Technical *data*

**CT 939 K2/K3 timing belt kit, used for example in:
VW / Audi 2.5 TDI 5 cyl.**

**Fig. 1
Washer**

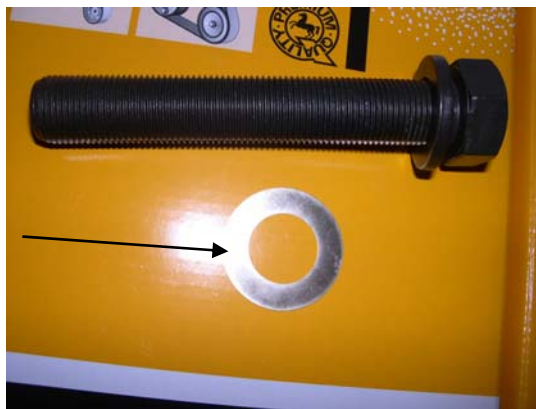
In accordance with the updated equipment status, the timing belt kit contains a thin washer (diamond-coated) that was not previously installed in the vehicle.

According to the VW/Audi catalog, this special washer (4) is to be installed between the crankshaft drive wheel (3) and the torsional vibration damper (5). This is intended to improve the co-efficient of friction.
